Regarding the Clover Valley Project:

Letter 182

ATTN: MS LAMARA WEBSTER
RE: CLOVER VALLEY LAKES
RECIRCULATED DRAFT ENVIRONMENTAL IMPACT
REPORT - REVIEW OF - JAN 2006 - AT
PUBLIC HEARING, FEB 23, 2006.

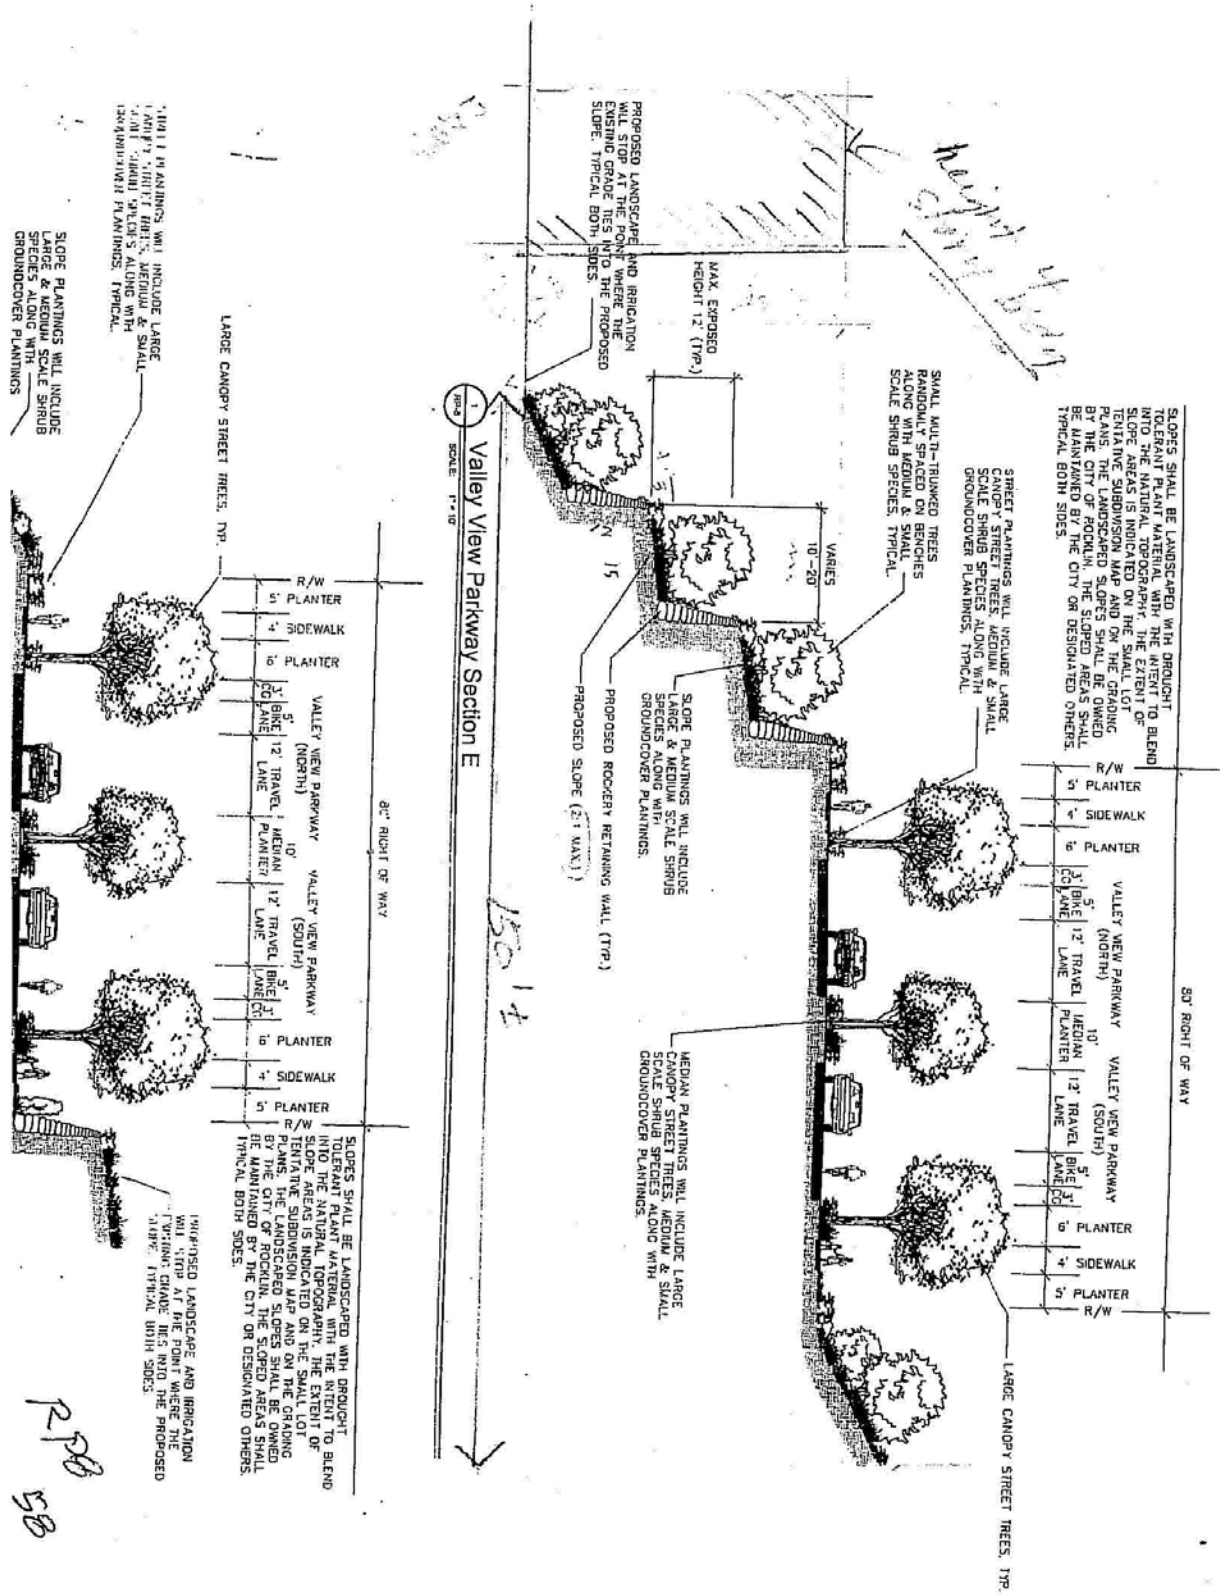
FEWER INTERSECTIONS KEEP TRAFFIC FLOWING BETTER. IT SEEMS THAT THE CLOSE PROXIMITY OF 2 INTERSECTIONS IN THE MIDDLE OF THE PROJECT MAY BE AMELIORATED BY MODIFYING WILD GINGER DR AT VVP, AND CONNECTING THE WILD GINGER DR TO NATURE TRAIL WAY. A SKETCH IS PROVIDED FOR REVIEW AND EVALUATION. IT WOULD ALLOW FLOW OF TRAFFIC BETTER THAN IF TRAFFIC WOULD HAVE TO STOP AT 2 INTERSECTIONS IN A SHORT DISTANCE OF ABOUT 400 FEET.

VALLEY VIEW PARKWAY SECTION B & SECTION C	SCALE:		SI
	DATE: AUGUST 2005		JOB NO. 044 38704

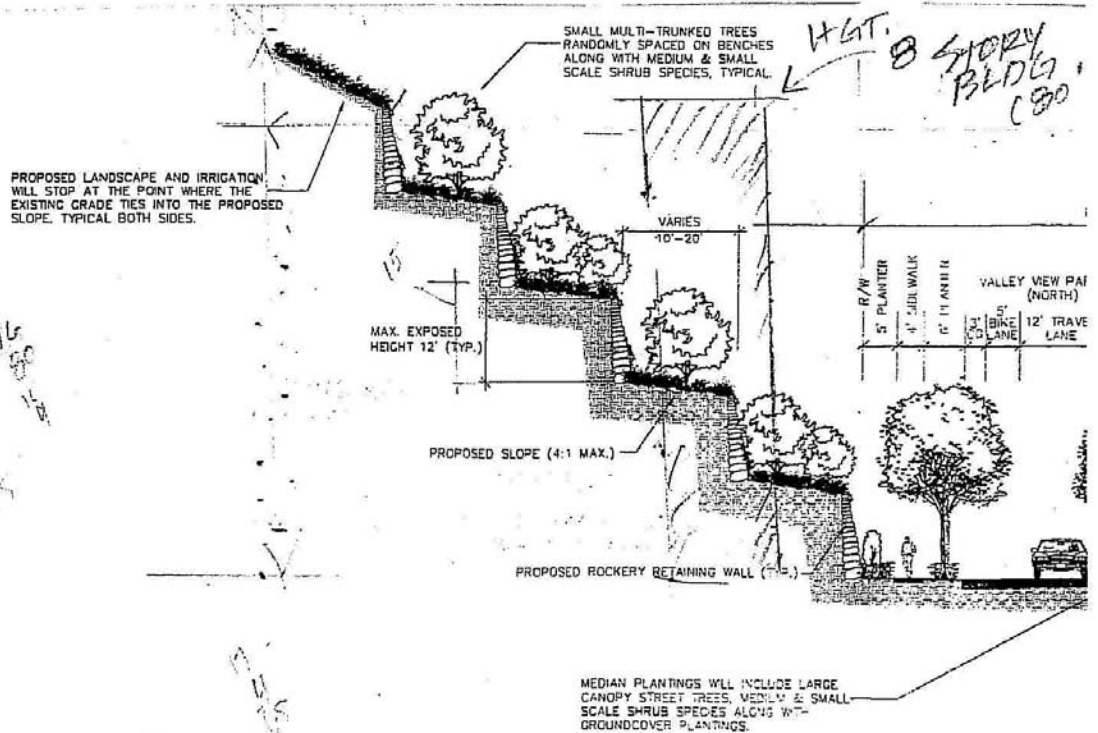
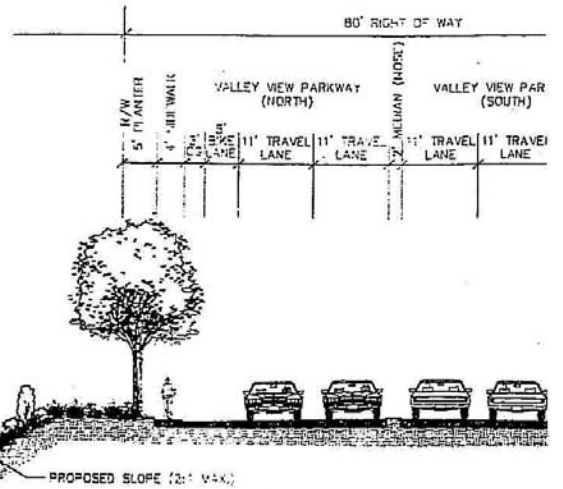
NEEDLESS TO SAY THE VVP WILL BE MUCH WORSE AT A 50% INCREASE OF GRADE (12%). PICTURE YOURSELF LIVING NEAR AND TRAVELING ON SUCH A ROADWAY.

CONTINUING ON NOISE GENERATION IT MAY BE BENEFICIAL TO CONSIDER THE METHOD USED TO REDUCE THE LATERAL DISTANCES THAT IT IS NECESSARY TO REDUCE THE FOOTPRINT OF GRADING BOTH ON VVP, AS WELL AS OTHER LOCATIONS IN THE PROJECT. THAT IS THE GENEROUS USE OF CONCRETE BLOCK WALLS, TO REDUCE CUT AND FILL SLOPES, WHICH WILL PLAY A NEGATIVE ROLE IN REDUCING NOISES EARLIER MENTIONED. IN CLOVER VALLEY THE CONFIGURATION OF THE HILLS AND THE NARROW VALLEY LEAD THEMSELVES TO THE TRANSMISSION OF NOISES GENERATED IN

↑ VALLEY. THE CONCRETE BLOCK WALLS, SOME RANGING FROM 40 TO 80 FEET HIGH. (CONSIDER THESE ARE LIKE 40 TO 80 STORY HIGH RISES) OTHERWISE FORMING CANYONS AND ECHO CHAMBERS REFLECTING NOISES ALL AROUND. THESE NOISES WILL REFLECT DOWN THE EXISTING CLOVER VALLEY DEVELOPED AREAS, DILUTING THE EXISTING HOMEOWNERS "QUALITY OF LIFE" DOWN THE ROAD FOR MANY DECADES, COULD THE CITY REQUEST THE DEVELOPERS TO PERFORM WHATEVER TESTING THEY MAY DO, MAYBE EVEN RESEARCHING LITERATURE TO GET A HANDLE ON WHAT IS AVAILABLE TO STUDY THE NEGATIVE EFFECT (MORE SO THAN WAS DONE IN THE EIR WHICH IS EXTENSIVE BUT MAY BE SHORT ON THIS SUBJECT
